752986/A/35/ E8

29 Jan 2026

**PROVN OF SINGLE MEN BARRACKS INCLUDING COOK HOUSE (IN EPC MODE) FOR AGNIVEERS  
 AT 1 STC JABALPUR**

- Reference Tender documents for the above-mentioned work uploaded on www.defproc.gov.in Portal having tender ID: **2025\_MES\_725970\_1** on dated 12 Sep 2025 vide this office letter No 752986/A/03/E8 dated 12 Sep 2025 and date corrigendum issued vide this HQ letter No. 752986/A/09/ E8 dated 10 Oct 2025, 752986/A/14/ E8 dated 31 Oct 2025 & 752986/A/17/E8 dated 14 Nov 2025, 752986/A/21/E8 dated 27 Nov 2025, 752986/A/23/E8 dated 22 Dec 2025, 752986/A/27/E8 dated 07 Jan 2026 & 752986/A/33/E8 dated 21 Jan 2026 and amendment to tender documents and BOQ issued vide this HQ letter No. 752986/A/19/E8 dated 15 Nov 2025.
- The following amendment shall be carried out / considered before submission of bid:-

GROUND FLOOR PLAN, ELEVATIONS

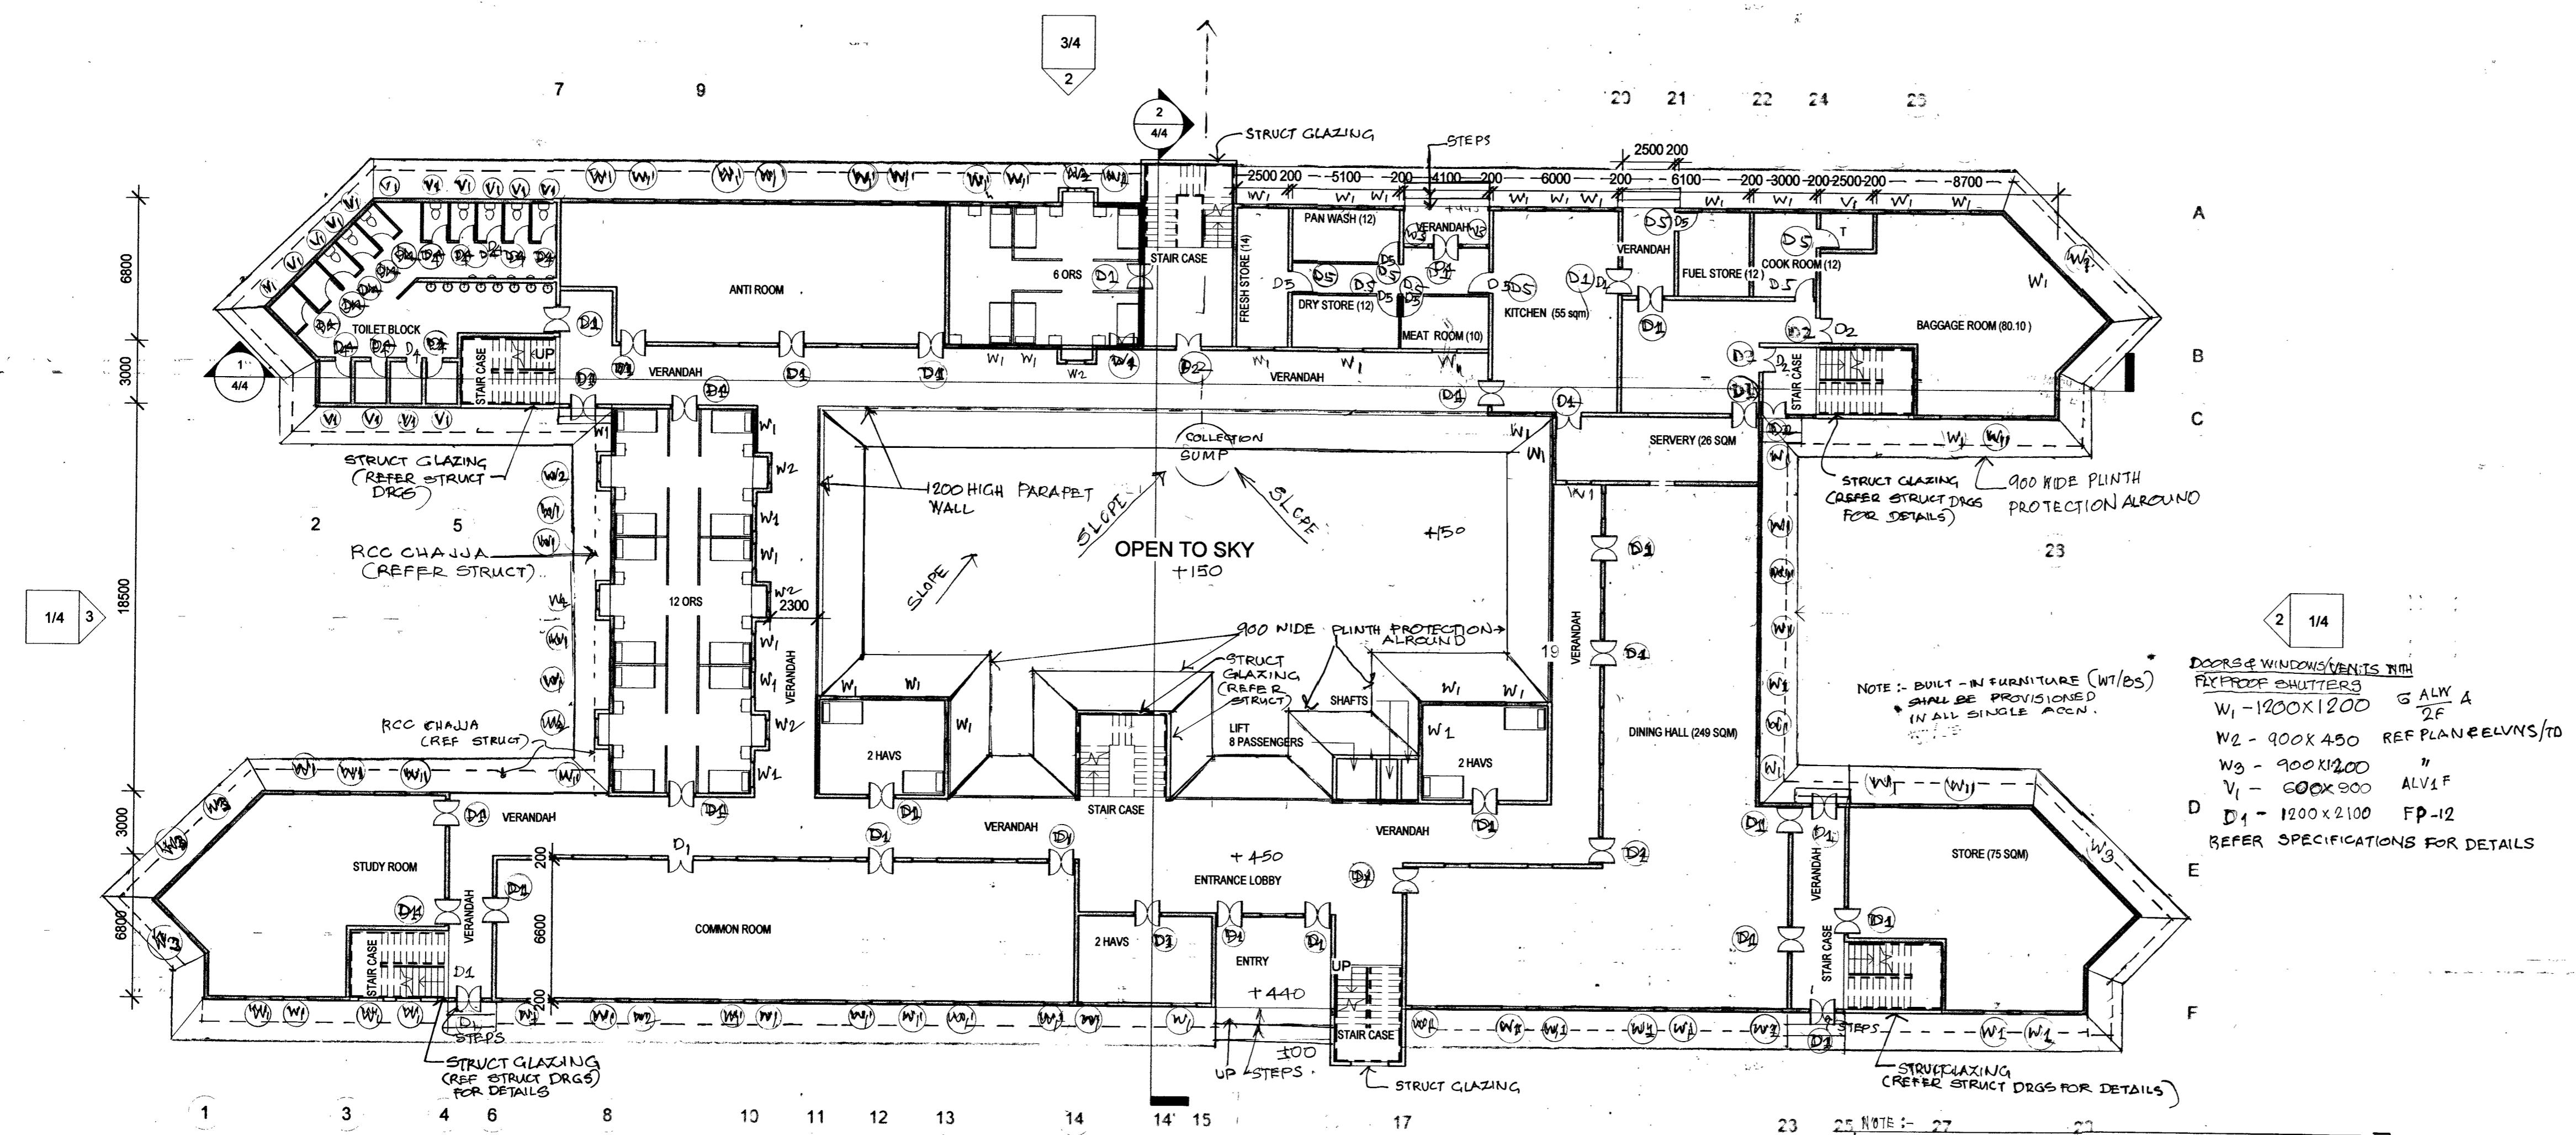
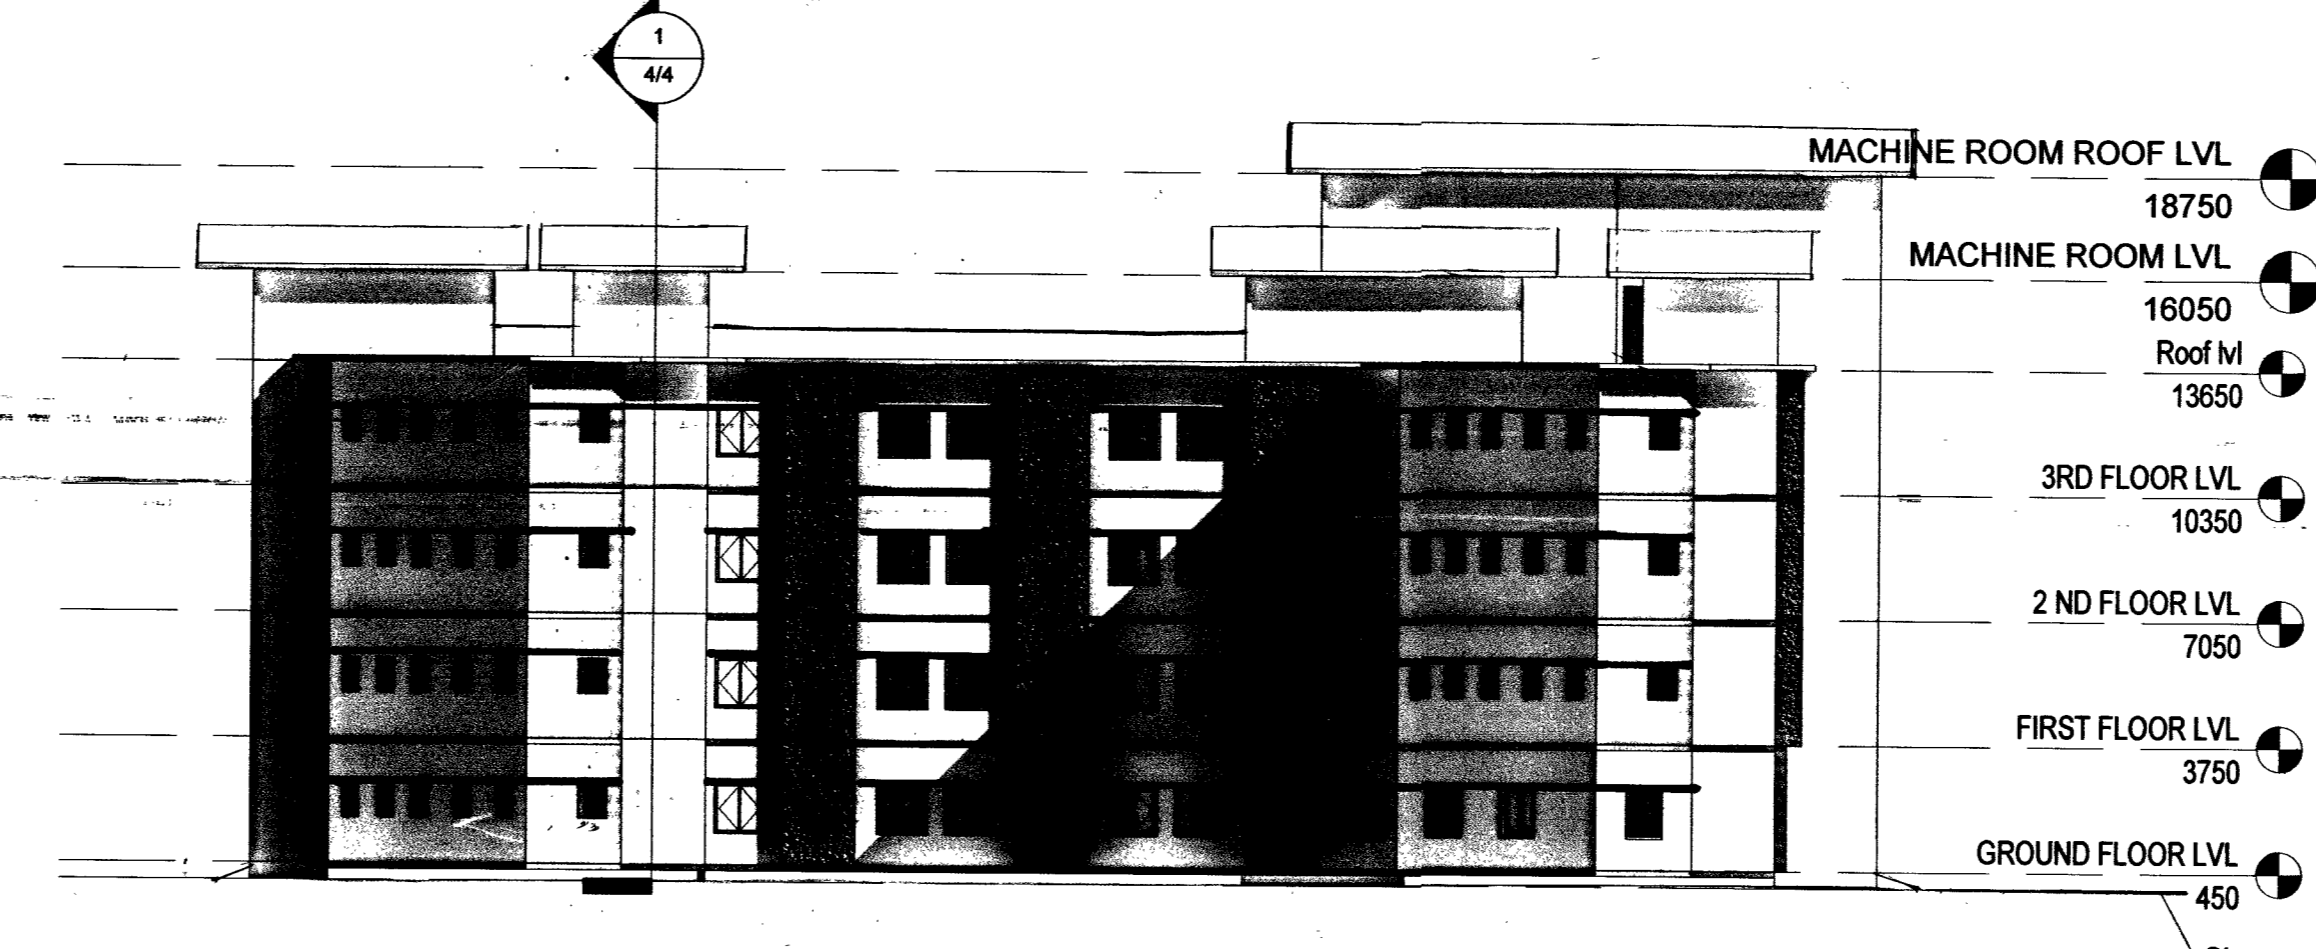
SI NO	DATE	DESCRIPTION	SIGN
1	23.01.2026	REVISED UP TO DATE	ND

TYPICAL FLOOR PLAN, ROOF PLAN & FRONT ELEVATION

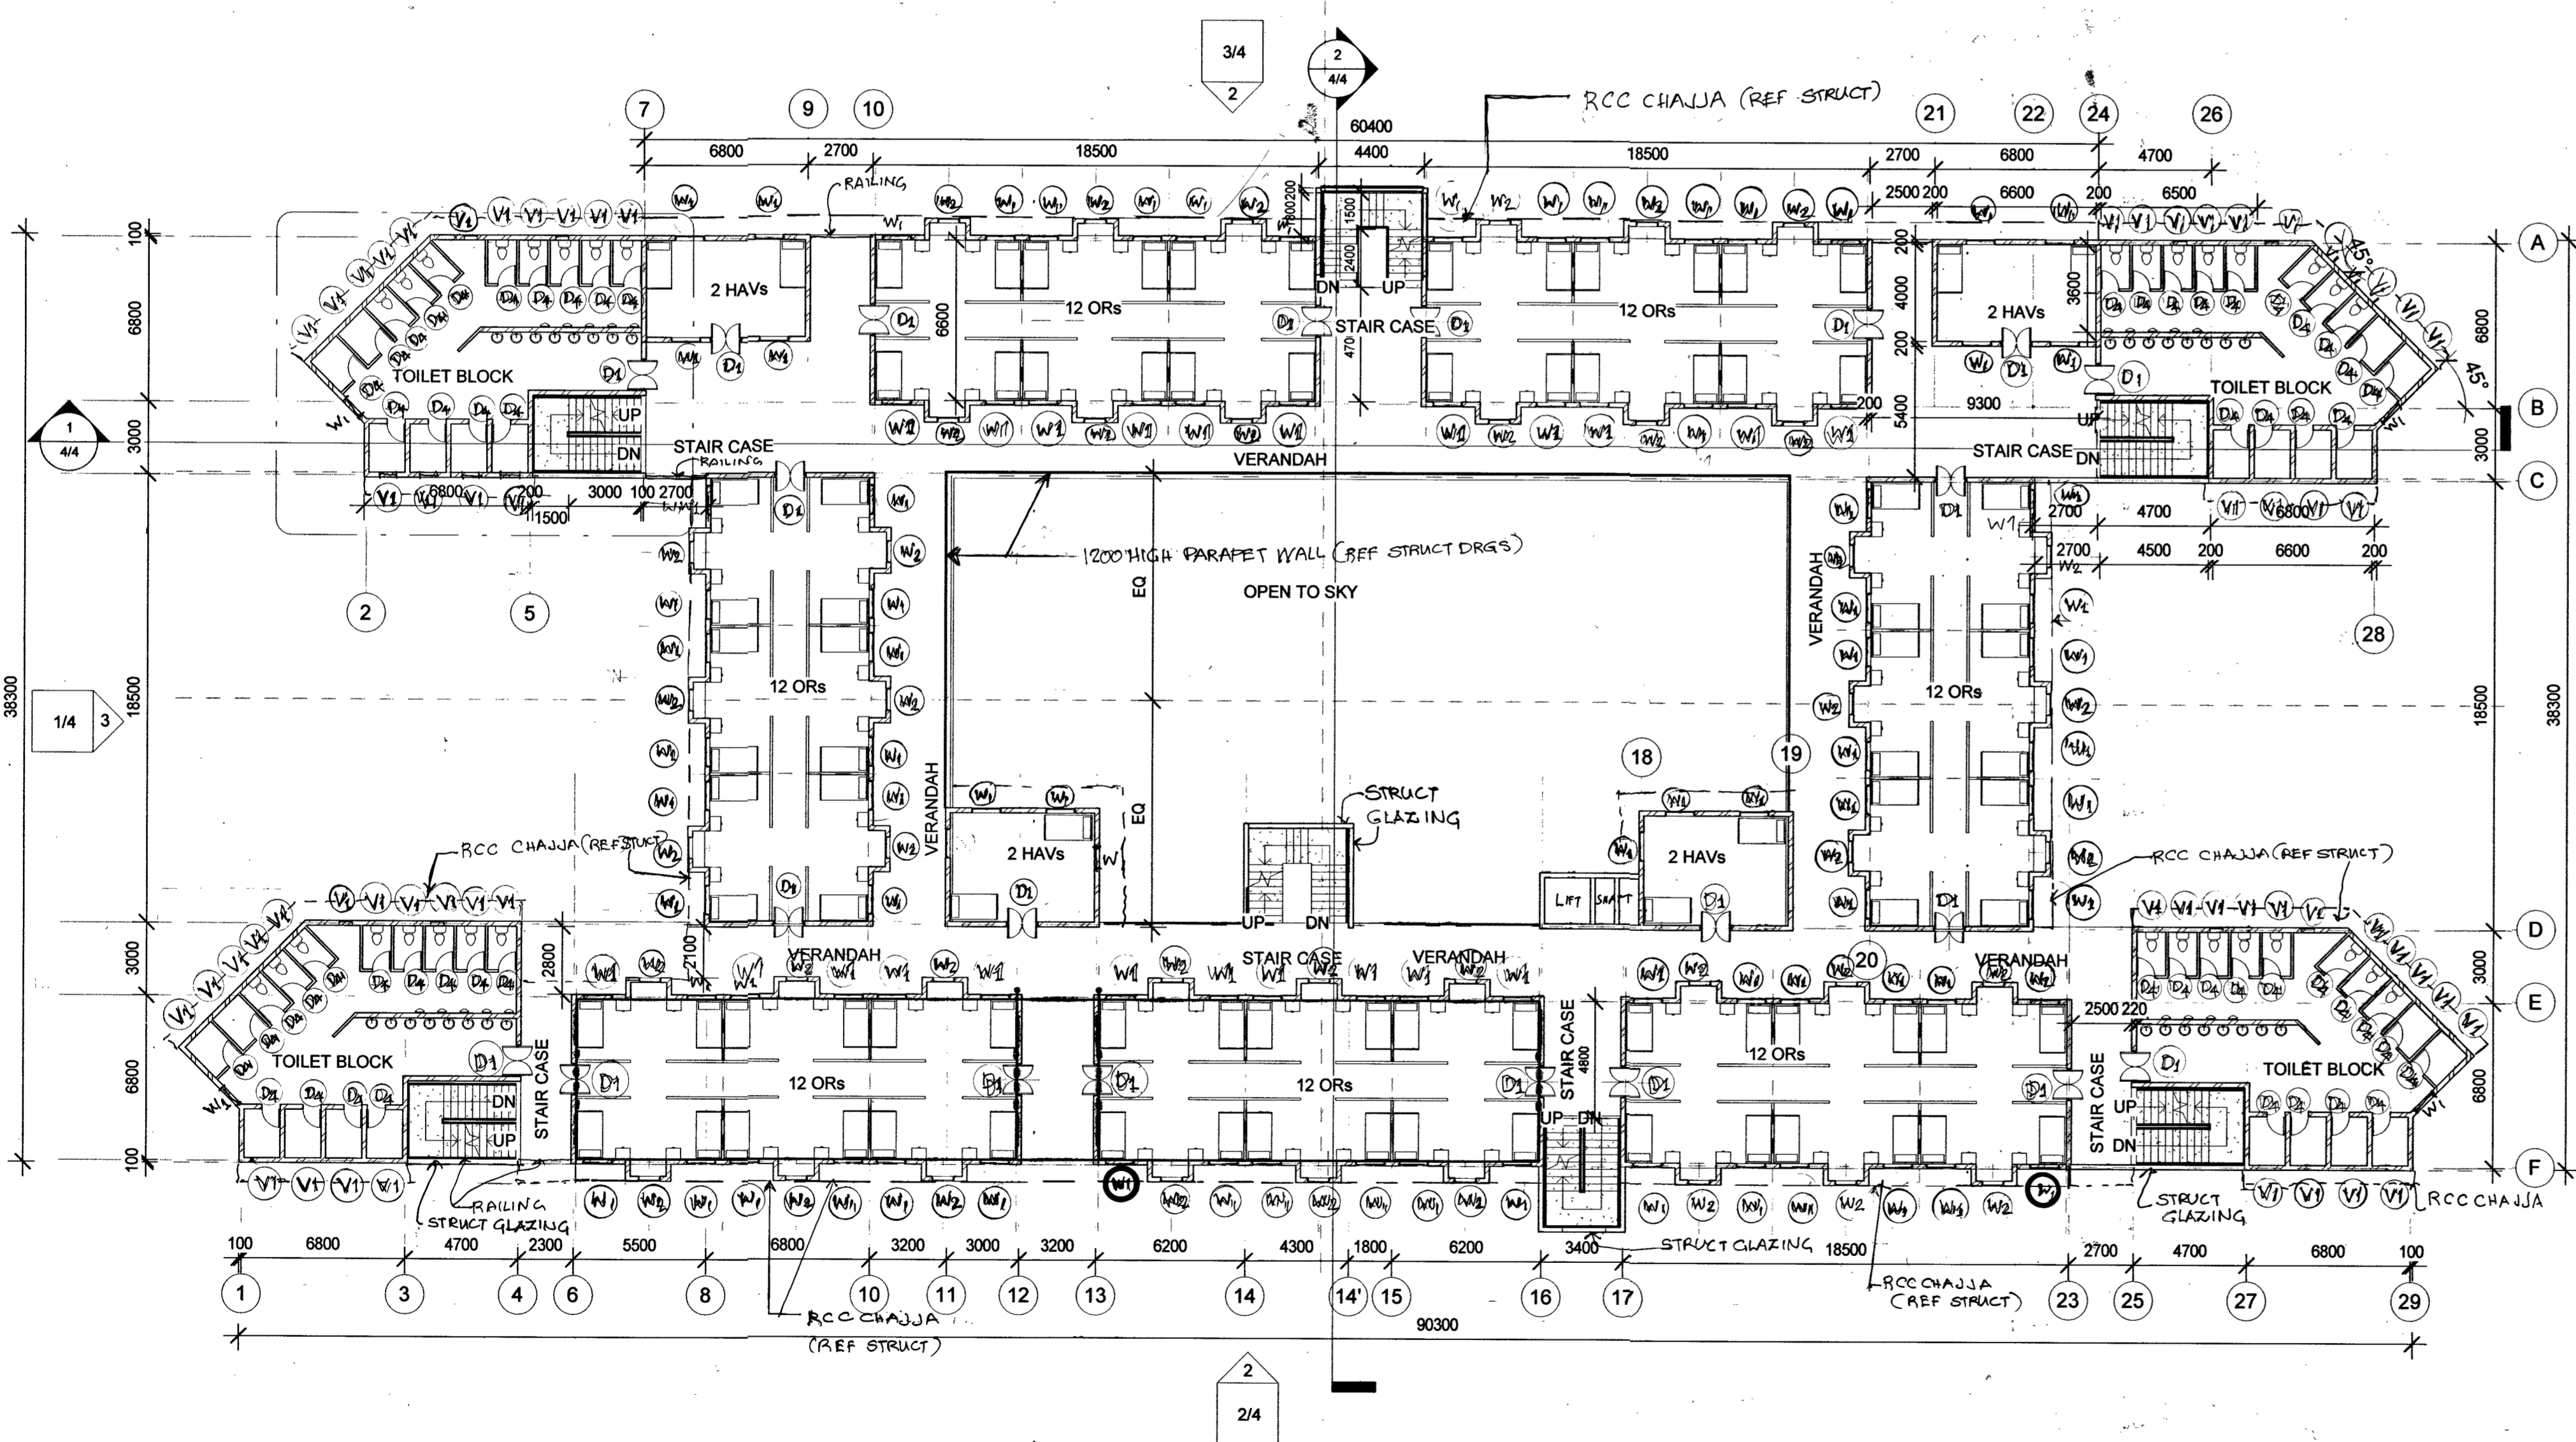
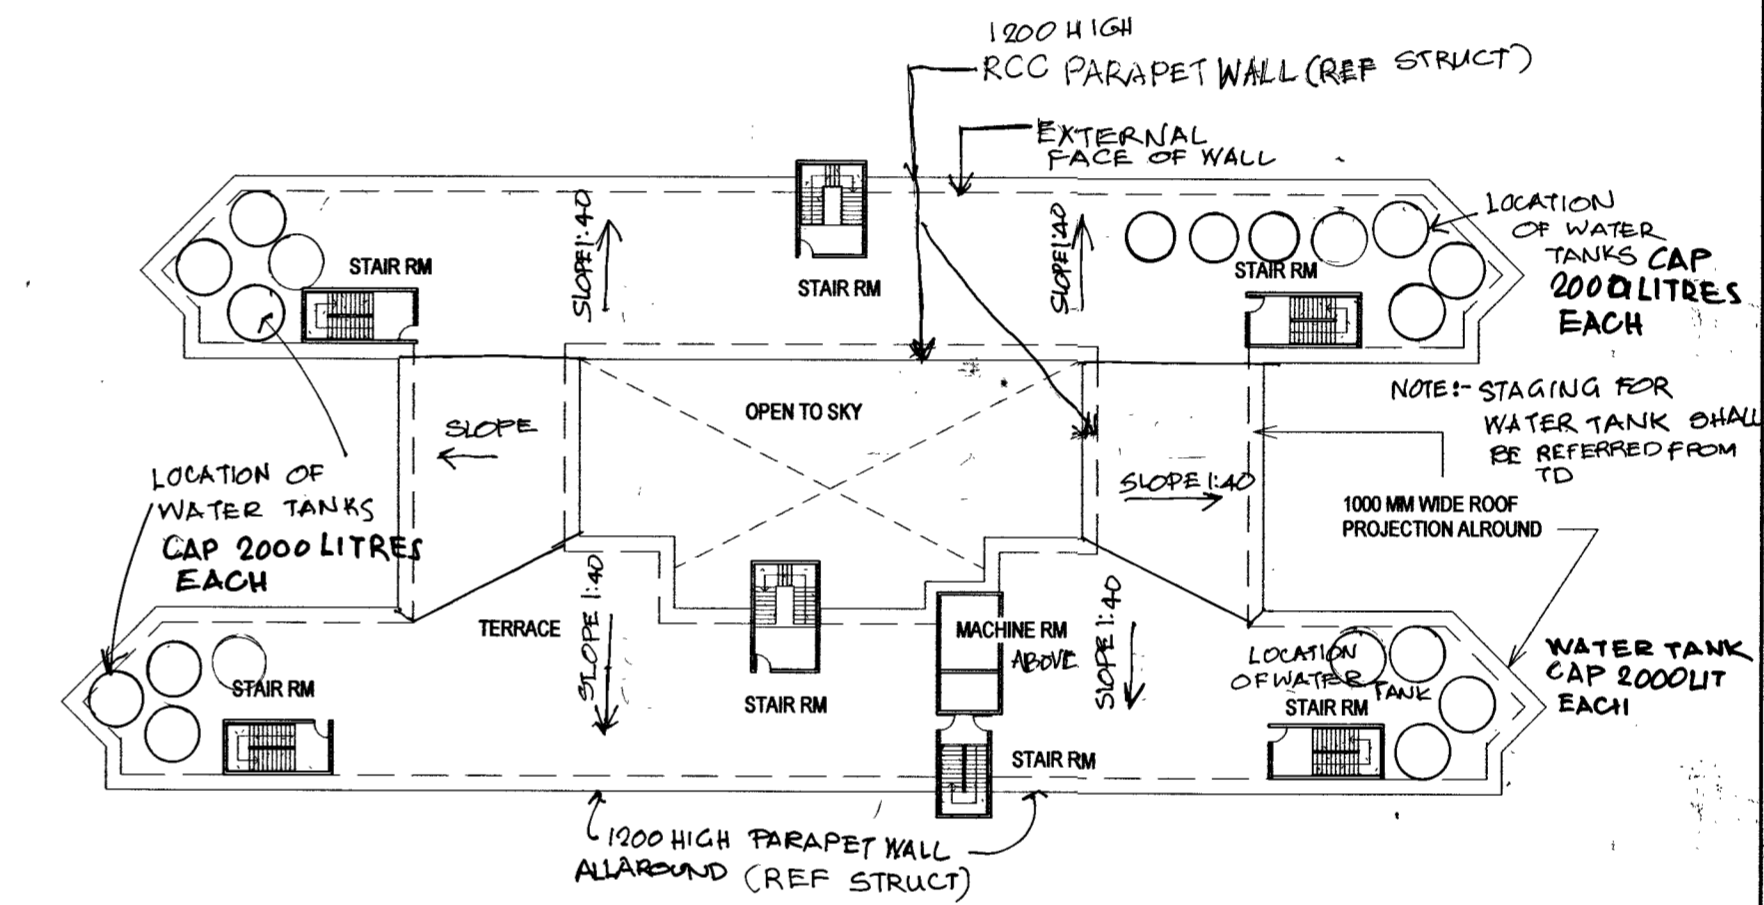
SL NO	DATE	DESCRIPTION	SIGN
3	23.01.2026	REVISED UP TO DATE (FRONT ELEVATION)	<i>[Signature]</i>
2	23.01.2026	REVISED UP TO DATE (ROOF PLAN)	<i>[Signature]</i>
1	23.01.2026	REVISED UP TO DATE (GROUND FLOOR PLAN)	<i>[Signature]</i>
